**LHC**

REFERENCE  
**LHC-Y-EC-0021**

## ENGINEERING CHANGE REQUEST

# LHC Safety System Modifications Due To HL-LHC During LS2

Figure 1 — Access element modifications for HL-LHC at Point 1. The circled areas (UA/UPR) are to be installed during LS2 and the rest (UL, LHC tunnel) during LS3 (a separate ECR). Similar modifications are foreseen in Point 5.

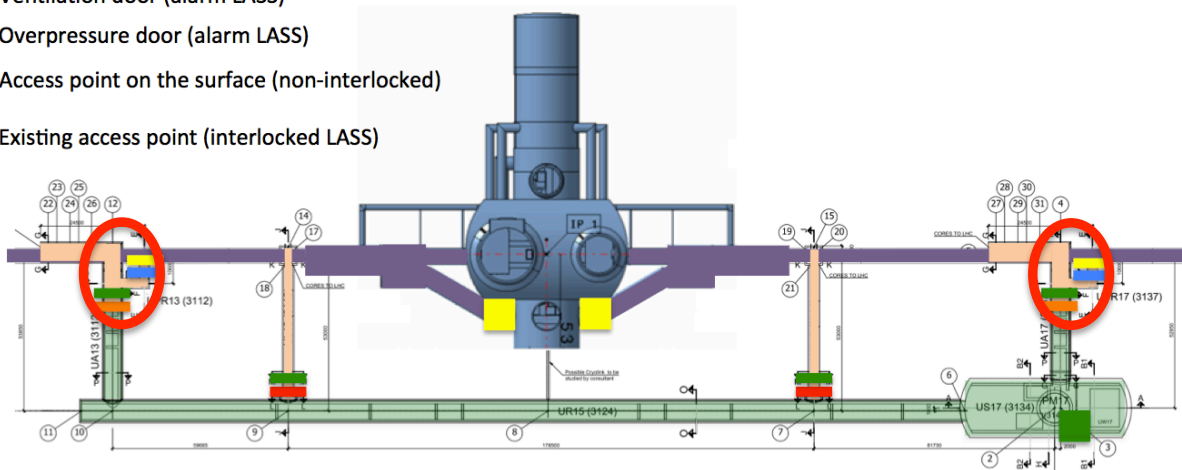
- New sectors: UPR13, UPR17, UPR53, UPR57.
- New end-of-zone doors: YCPZ01=UA13, YCPZ01=UA17, YCPZ01=UA53, YCPZ01=UA57.
- New sector doors: YCPS01=UPR13, YCPS01=UPR17, YCPS01=UPR53, YCPS01=UPR57.

- New ventilation doors: YCPV01=UA13, YCPV01=UPR13, YCPV01=UA17, YCPV01=UPR17, YCPV01=UA53, YCPV01=UPR53, YCPV01=UA57, YCPV01=UPR57.
- New patrol boxes: YZBPA01=UPR13, YZBPA02=UPR13, YZBPB01=UA13, YZBPA01=UPR17, YZBPA02=UPR17, YZBPB01=UA17, YZBPA01=UPR53, YZBPA02=UPR53, YZBPB01=UA53, YZBPA01=UPR57, YZBPA02=UPR57, YZBPB01=UA57.

- Grated end-of-zone door (interlocked LASS)
- Solid end-of-zone/ventilation door (interlocked LASS)
- Grated sector door (interlocked LASS)
- Ventilation door (alarm LASS)
- Overpressure door (alarm LASS)
- Access point on the surface (non-interlocked)
- Existing access point (interlocked LASS)

- Inner triplet area (interlocked LASS)
- Non-accessible HL-LHC galleries (interlocked LASS)
- Accessible HL-LHC galleries (non-interlocked)

Figure 2 — Integration model view of the the new racks YYACS09=SD1 and YYACS10=SD1 at SD1.

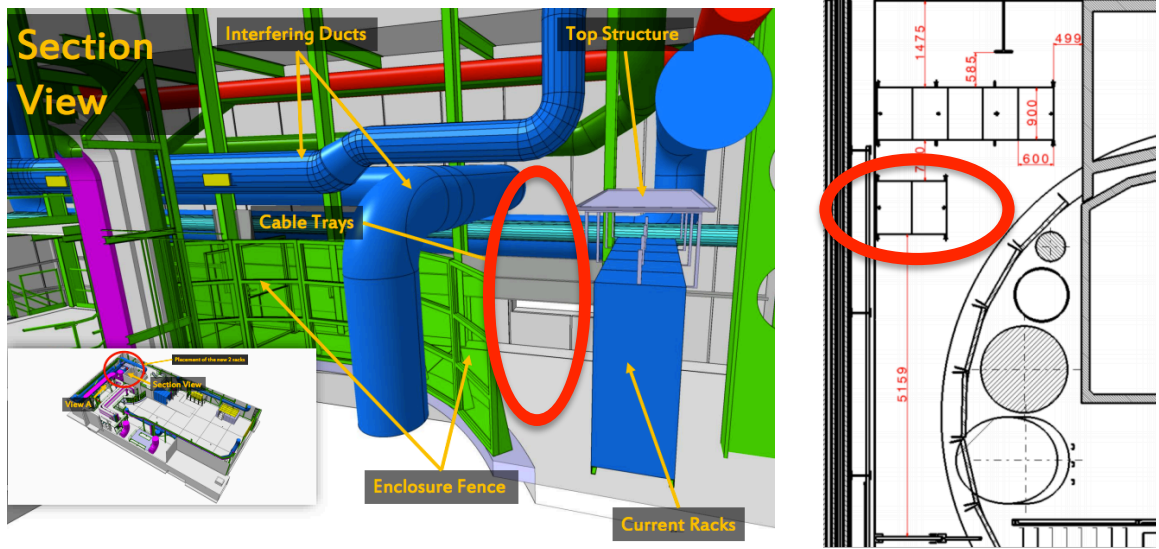
- New racks (installation by CERN, connection boards by Mobility/Actemium):
  - YYACS09=SD1 and YYACS10=SD1 at PM15.
  - YYACS09=SD5 and YYACS10=SD5 at PM56.

Figure 7 — Approximate positions of ODH detectors and flashes in UA17 and UPR17 (similar positions in other UAs and UPRs).

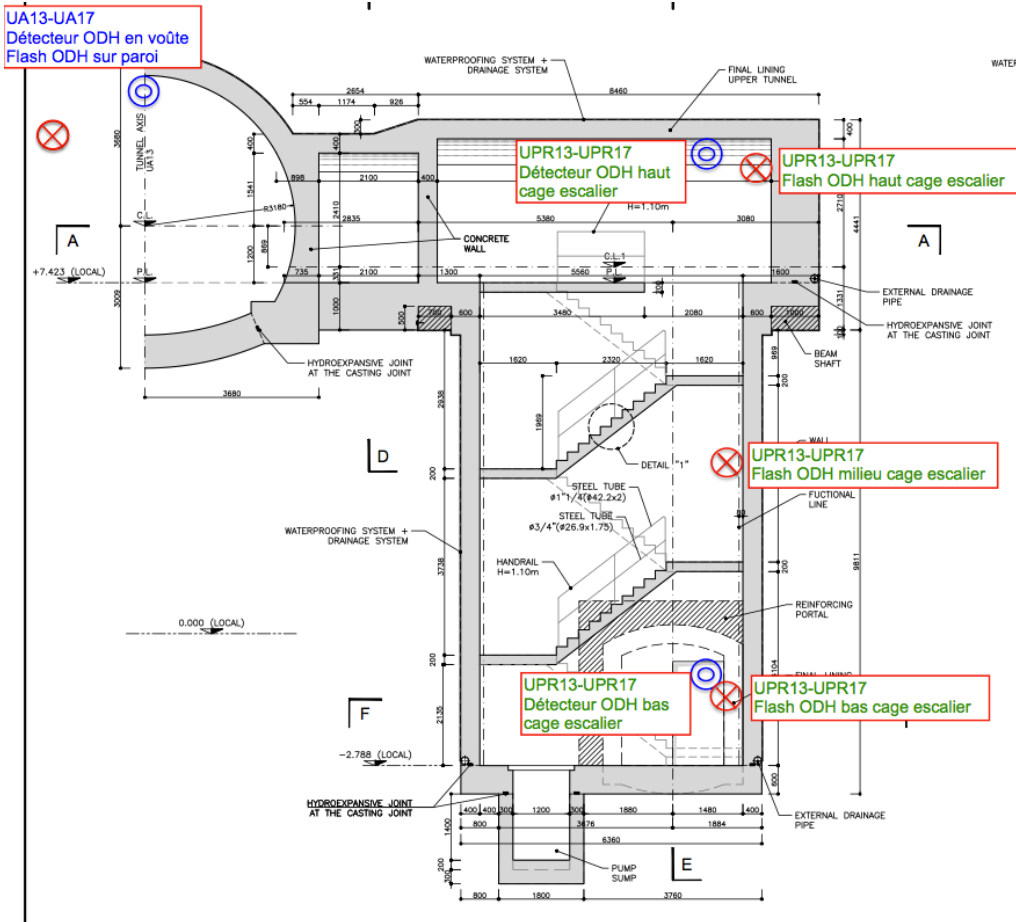
- 1 ODH detector in UA13, UA17, UA53, UA57.
- 2 ODH detectors in UPR13, UPR17, UPR53, UPR57.
- Cabling for each individual ODH detector from service areas of Point 1.
- 1 ODH flash signal in UA13, UA17, UA53, UA57.
- 3 ODH flash signals (one at top, one at middle, one at bottom) in UPR13, UPR17, UPR53, UPR57.
- Cabling for each individual ODH detector from service areas of Point 5.

Figure 11 — Approximate positions of red telephones in UA57 and UPR57 (positions in other UAs and UPRs are similar).

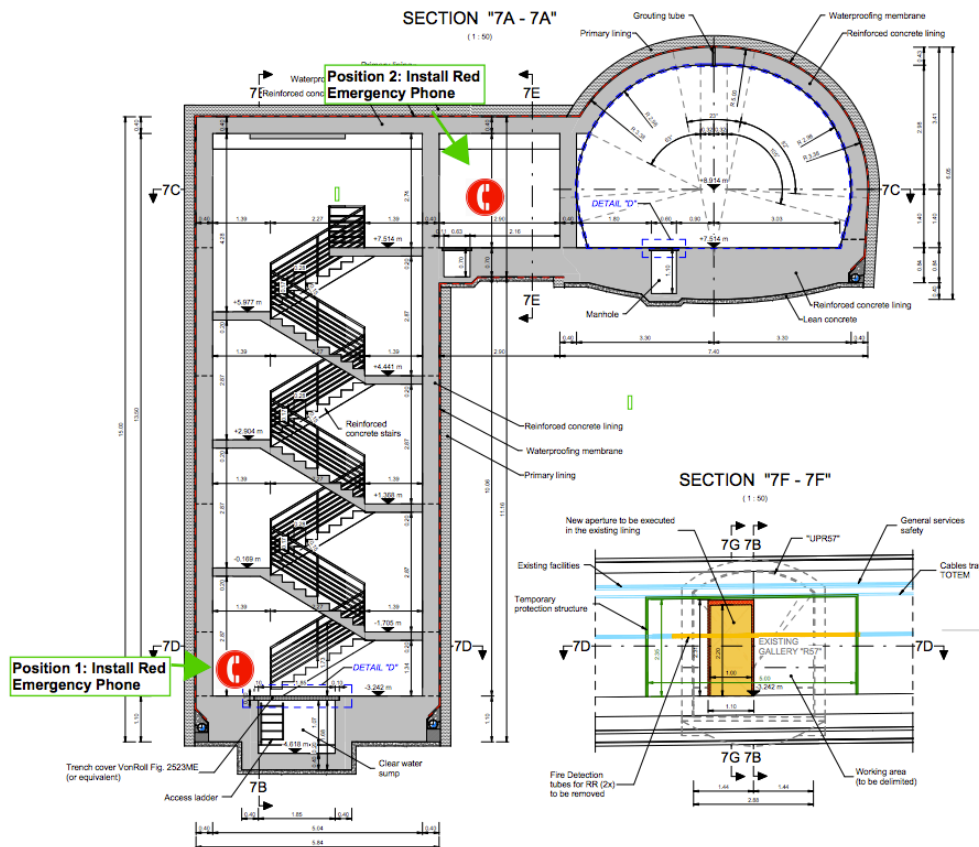
- 2 red telephones in each UPR (UPR13, UPR17, UPR53, UPR57), one at top of stairs, one at the bottom.
- Cabling for red telephones in each UPR from the service areas of P1 and P5 (one cable per two phones).

Figure 13 — Integration model view of the positioning of the "Crome" radiation monitor and the flash unit outside of the interlocked area in the UA gallery in the final configuration.

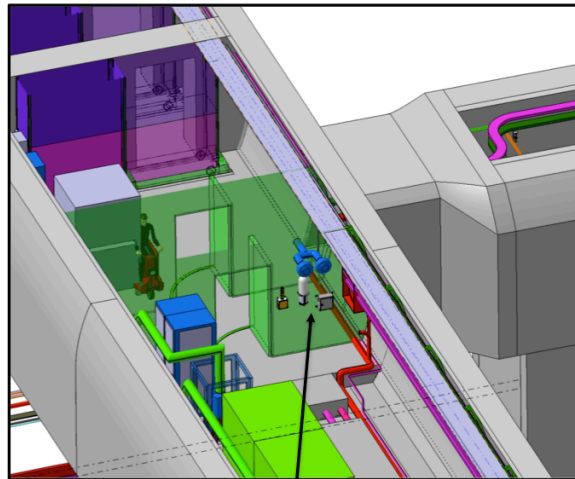
- 1 RAMSES "Crome" radiation monitor and one signalling flash light outside of the interlocked zone of each UA gallery (UA13, UA17, UA53, UA57).
- 1 uninterruptible power unit on the interlocked side of each UA gallery.

Figure 15 — Positions of the Fire Brigade tractor and trailer (after LS2) as well as the STORZ and RIA/STORZ equipment (after LS3) in the UA.

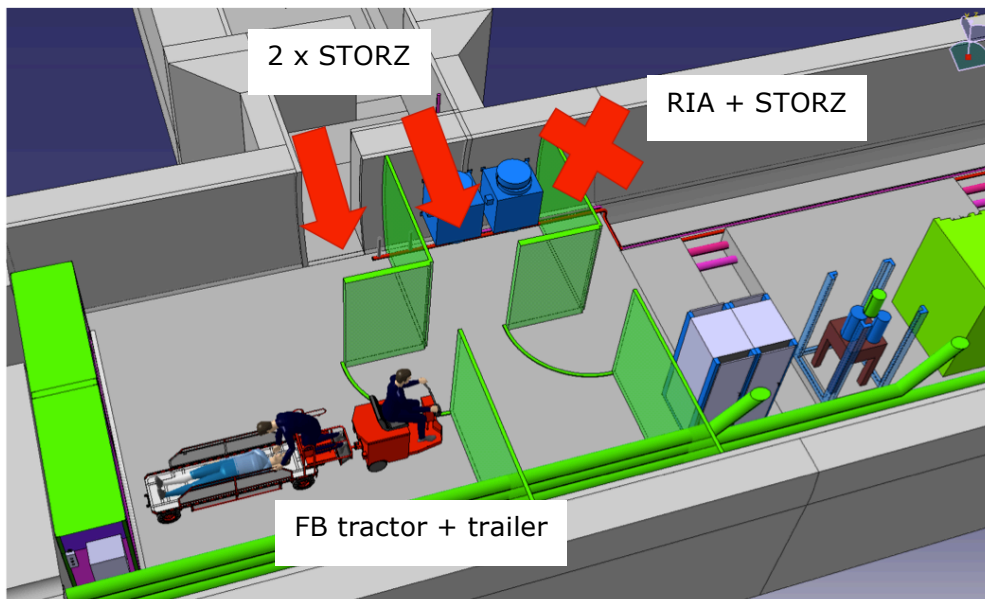
In the final configuration after LS3 there will be RIA/STORZ installed for fighting fire. However, after LS2 these equipment will not yet be available.

The Fire Brigade will position an electrical 2-seat tractor and a fire intervention trailer equipped with a CAFS (Compressed Air Foam System), spare SCBA (Self-Contained Breathing Apparatus), hose loads, forcible entry tools and extinguishers into the interlocked part of the UA.

Figure 16 — Integration model view of the location of the IT starpoint rack in the UPR17.

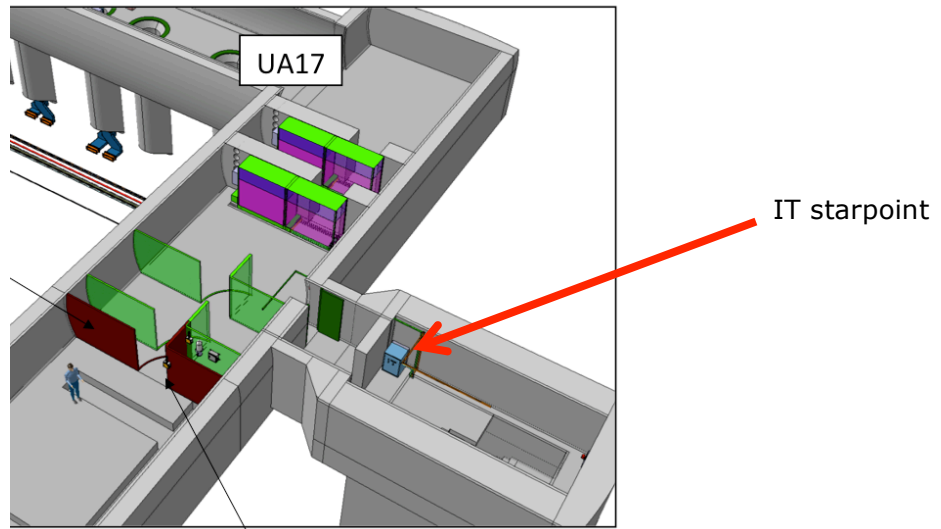
An IT starpoint will be installed in each UPR to provide Technical Network connectivity to systems that require it. Of the safety systems, only RAMSES monitoring will be connected to the Technical Network. The list of equipment to be installed is:

- IT starpoint rack on the top level of each UPR.
- Fiber-optic cabling from the closest IT starpoint in the service areas of P1 and P5.
- Network sockets and local cabling from the starpoint rack to each socket: 6 sockets in each UA, 2 sockets at the top of each UPR and 4 sockets at the bottom of each UPR.

Figure 17 — Integration model view of the locations of ODH detector, flashing light, red telephone, evacuation break-glass device and siren, as well as AUG at the bottom of a UPR (courtesy of XXX).

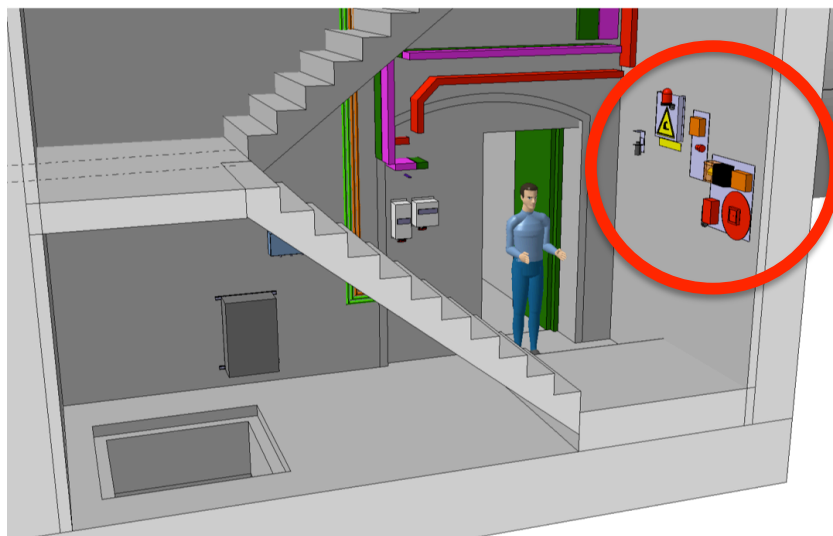
- 2 sirens for evacuation signal and BIW inside every UPR (UPR13, UPR17, UPR53, UPR57), one at the top of stairs, one at the bottom
- 2 evacuation buttons (break-glass device) in each UPR (UPR13, UPR17, UPR53, UPR57), one at the top of stairs, one at the bottom.
- Standard signalisation of evacuation routes to be installed by HSE / TSOs.

AUG is to be installed in the UPR.
